In the Matter of)
) Docket Nos. 50-237-SP
COMMONWEALTH EDISON COMPANY) 50-249-SP ✓
) (Spent Fuel Pool
(Dresden Station, Units 2 & 3) Modification)

LICENSING REPORT
DRESDEN NUCLEAR POWER PLANT
UNITS 2 AND 3
SPENT FUEL RACK MODIFICATION

DOCUMENT #: QUAD-1-79-234

REVISION SHEET

DRESDEN UNITS NO. 2 & 3
FUEL STORAGE POOL ARRANGEMENT

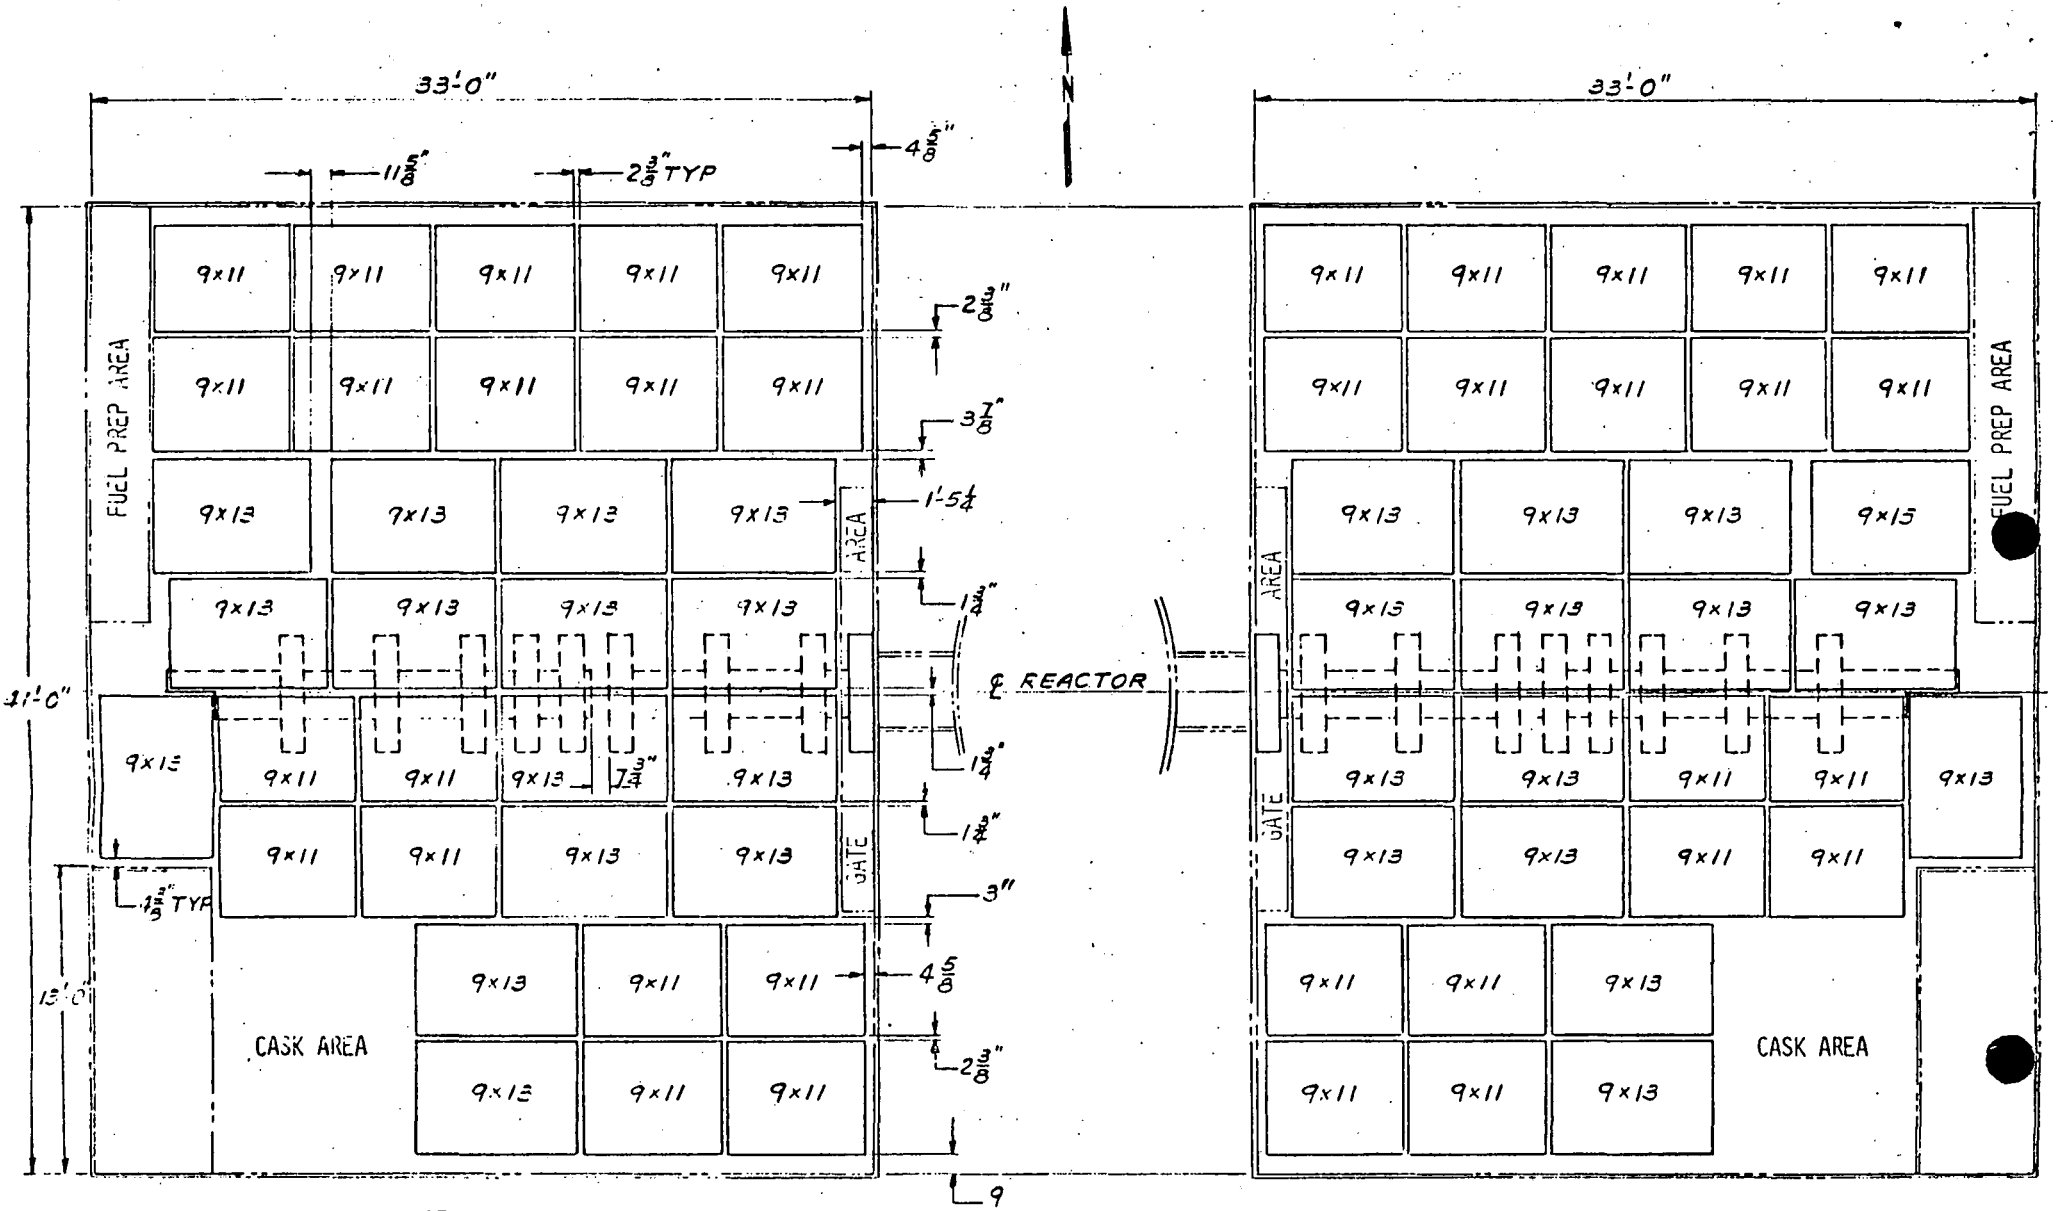
3.	Table 3.1-1 - Modification in accordance with revised storage capability and fuel discharge schedule.	3-2 3-2
4.	Figure 3.1-2 - Revised figure to reflect retention of fuel prep. area and gate storage area.	3-5

FIGURE 3.2-1. STAINLESS STEEL TUBE
WITH BORAL CORE
FOR DRESDEN FUEL STORAGE

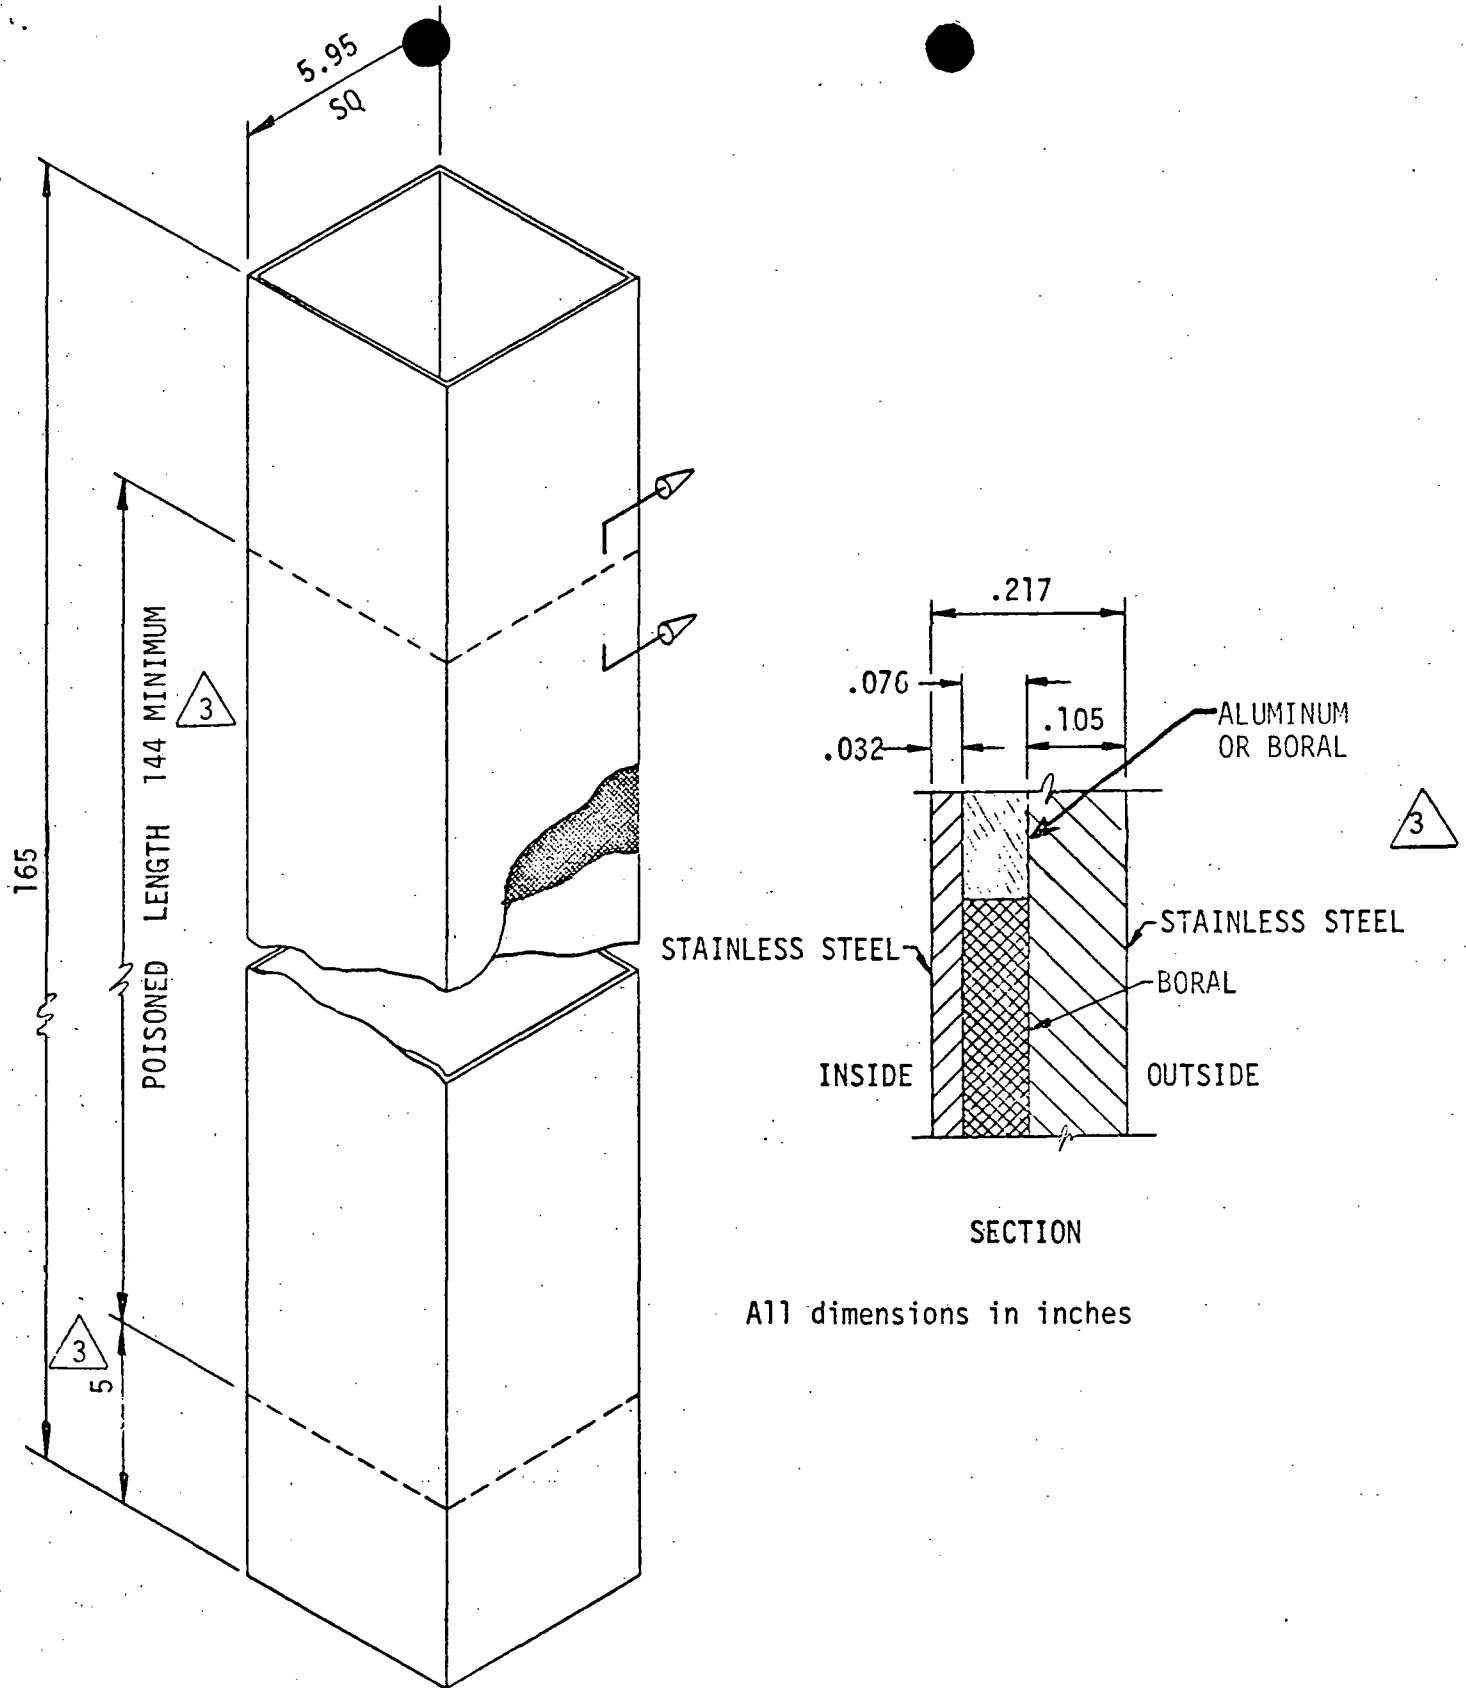
5.	Section 3.2 - Revised number of racks.	3-6
6.	Figure 3.2-1 - Revision of poisoned length from 144 inches to 144 inches minimum and the dimension indicating the location of poison from the bottom of the tube.	3-7

FIGURE 3.2-2. 9 X 13 SPENT FUEL RACK
DRESDEN UNITS 2 AND 3

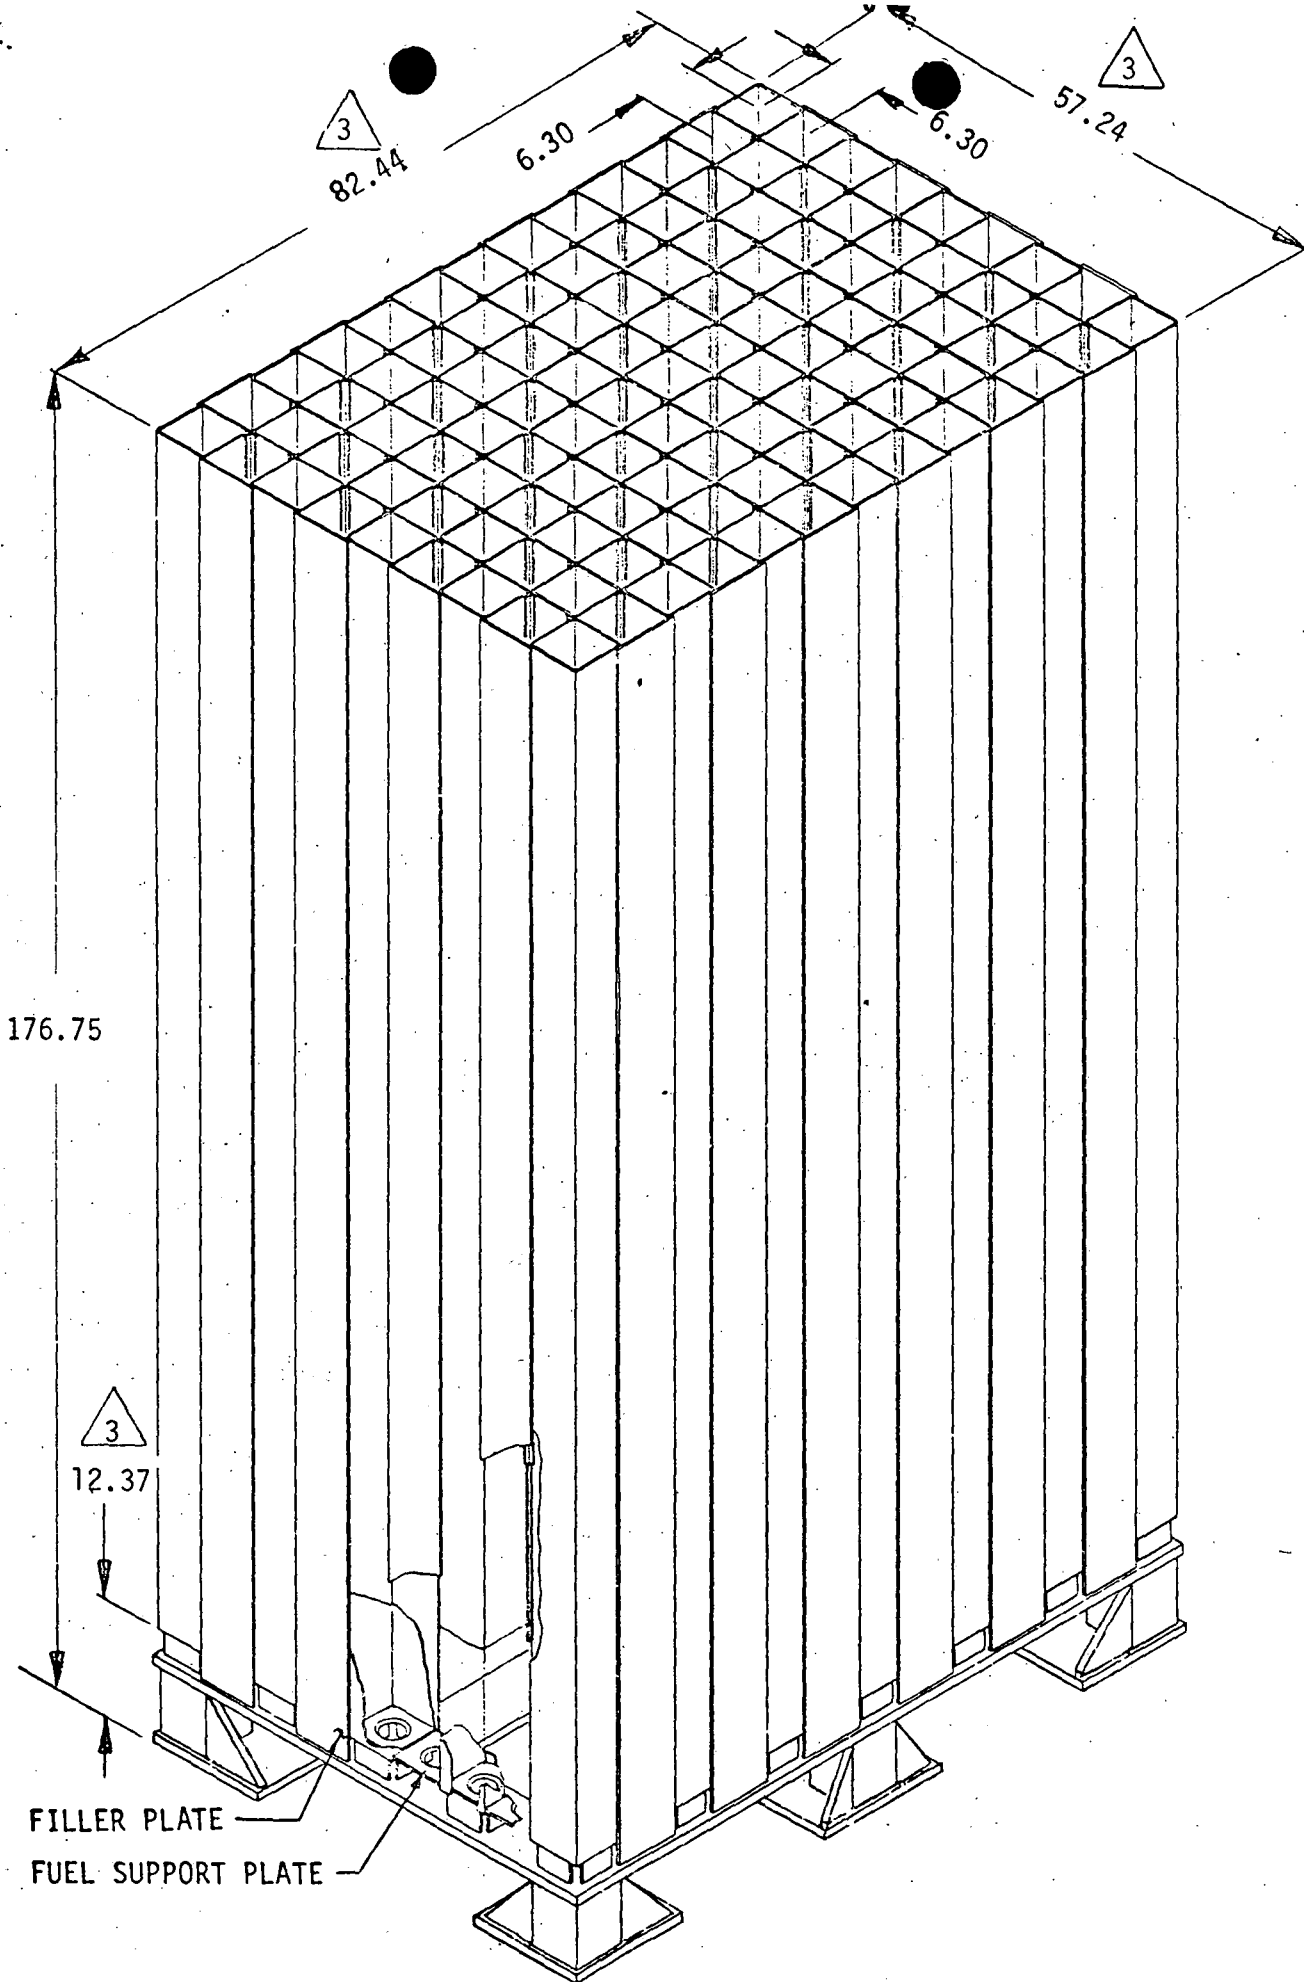
7.	Figure 3.2-2 - Revised overall width of fuel rack and revised elevation of fuel support plate.	3-8
8.	Table 3.3-1 - Revised Δk_3 and k_{eff} .	3-10
9.	Section 3.3.5 - Revised k_{eff} for condition 5.	3-16

FIGURE 3.3-6. RACKS IN CONTACT WITH EACH OTHER

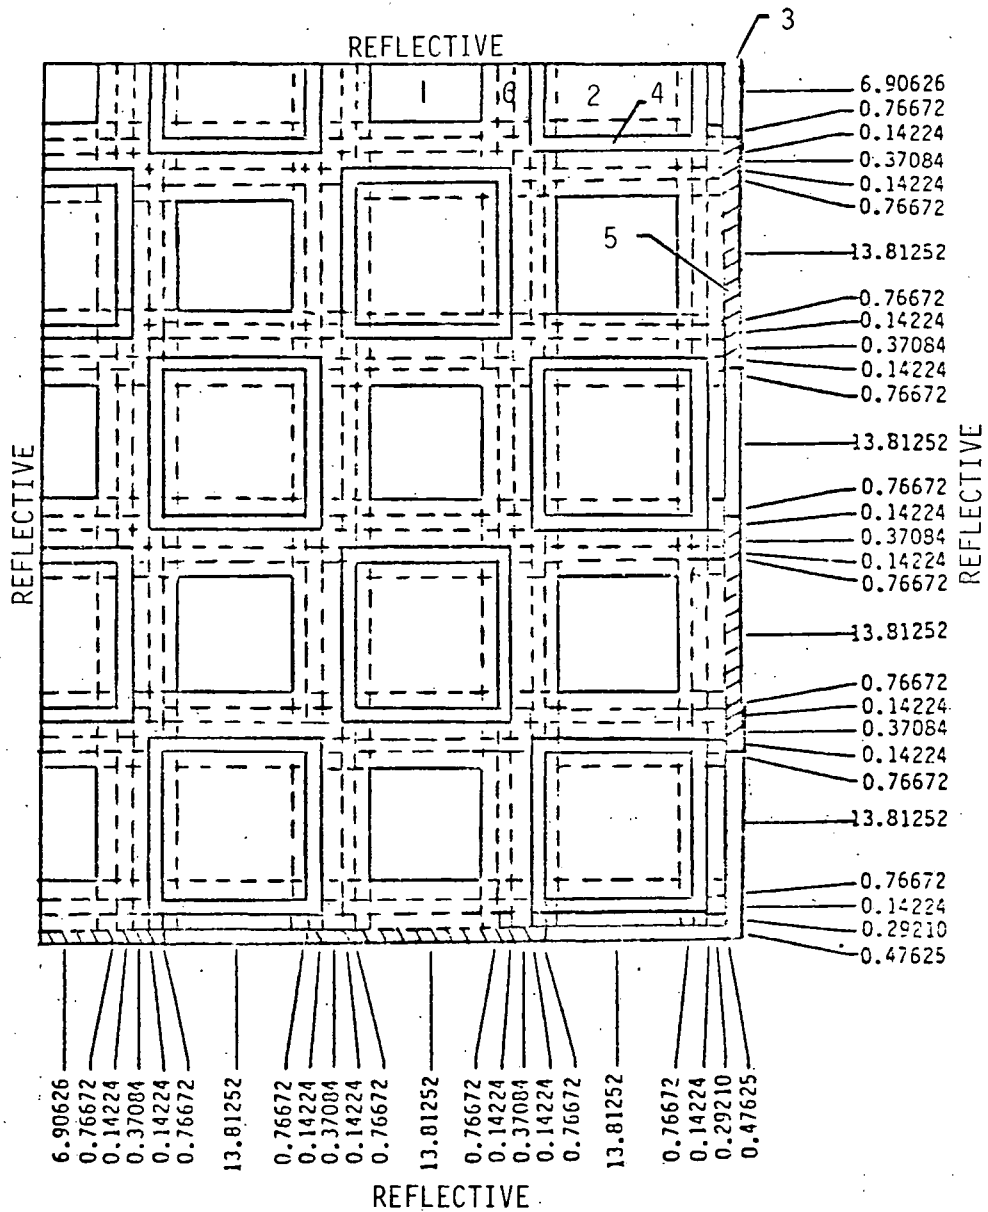
10.	Figure 3.3-6 - Revised figure to reflect the correct geometry of the fuel racks.	3-26
11.	Figure 3.3-9 - Revised figure to include k_{eff} at a pitch of 6.2 inches.	3-29

FIGURE 3.6-8:

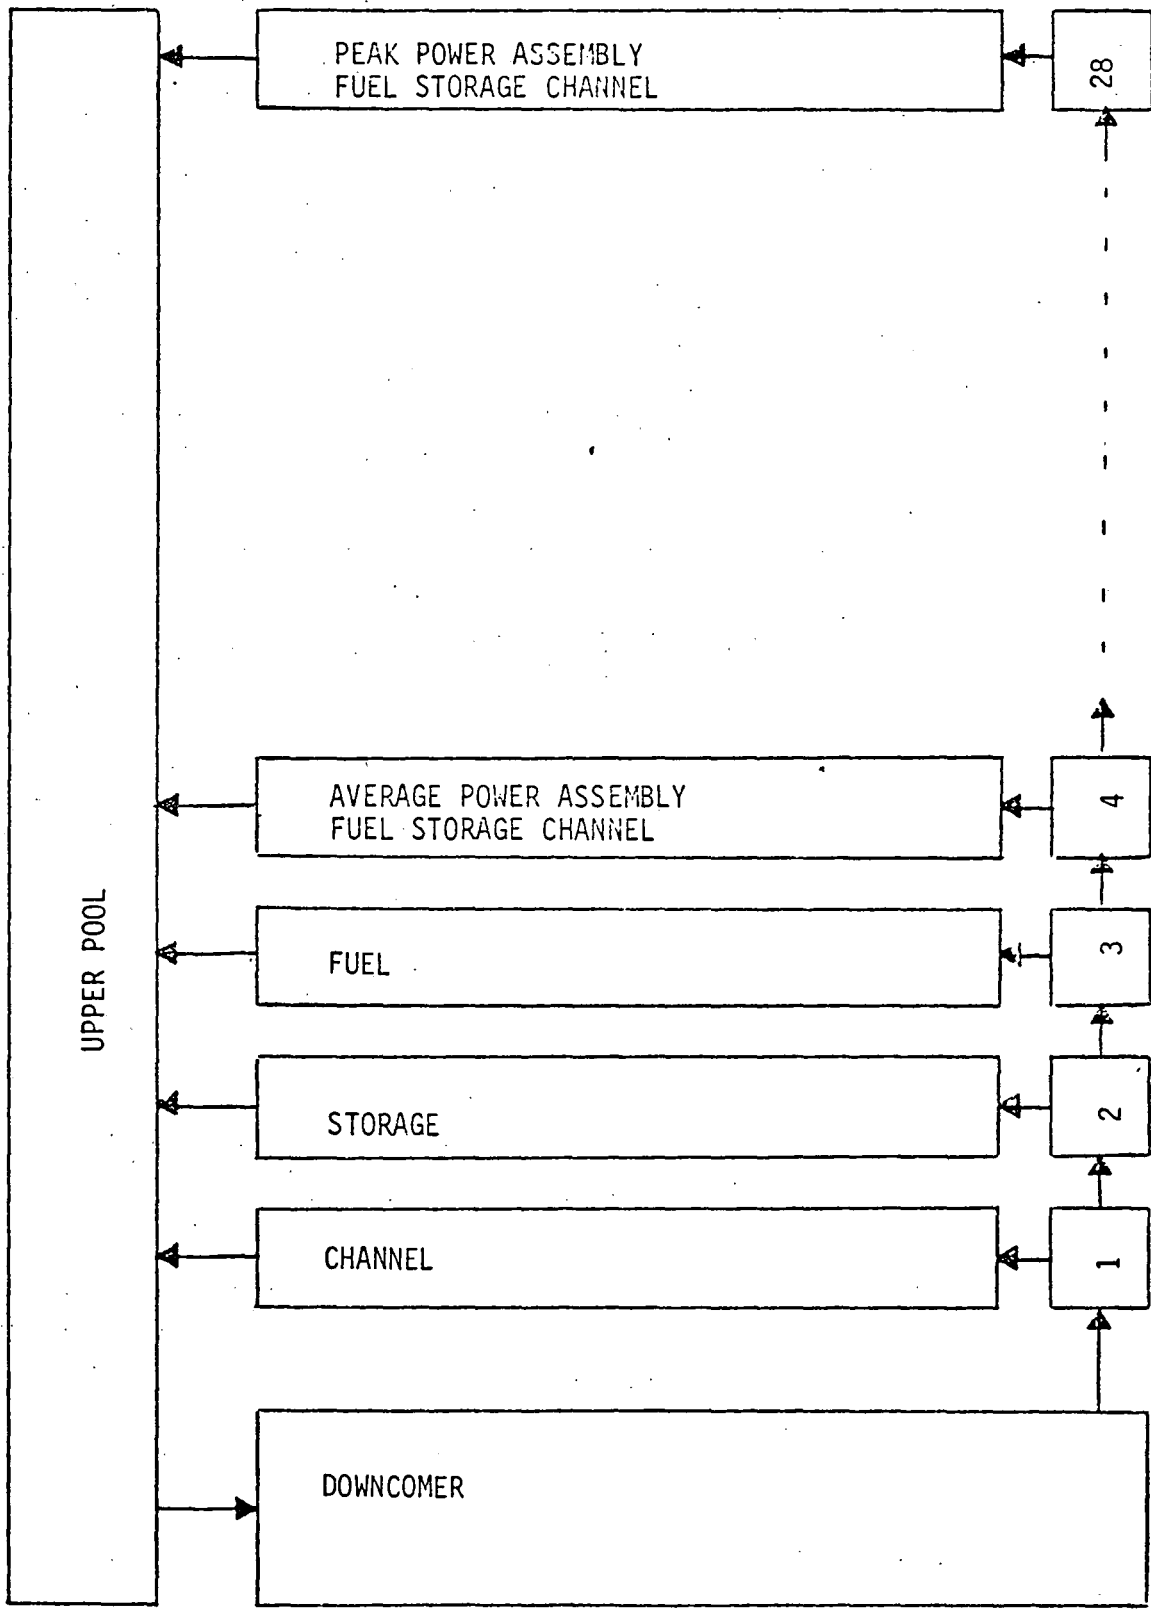
12.	Figure 3.6-8 - Number of flow channels changed from 30 to 28.	3-64
13.	Figure 3.6-9 - Revised fuel storage pool arrangement.	3-65
